PCN-20190105 TE0706-02 to TE0706-03 Hardware Revision Change

Company	Trenz Electronic GmbH
PCN Number	PCN-20190105
Title	TE0706-02 to TE0706-03 Hardware Revision Change
Subject	Trenz Electronic TE0706 Hardware Change
Issue Date	2019-04-11

#8 VBAT connector fitted

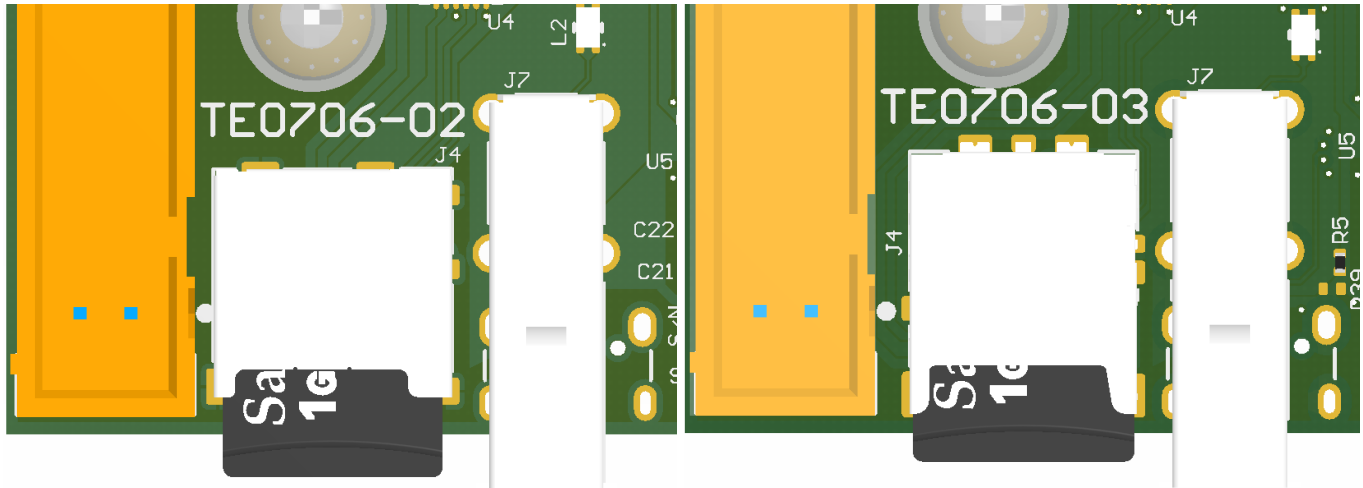
Type: Assembly change

Reason: Change from THT to SMD

Impact: Connector assembled
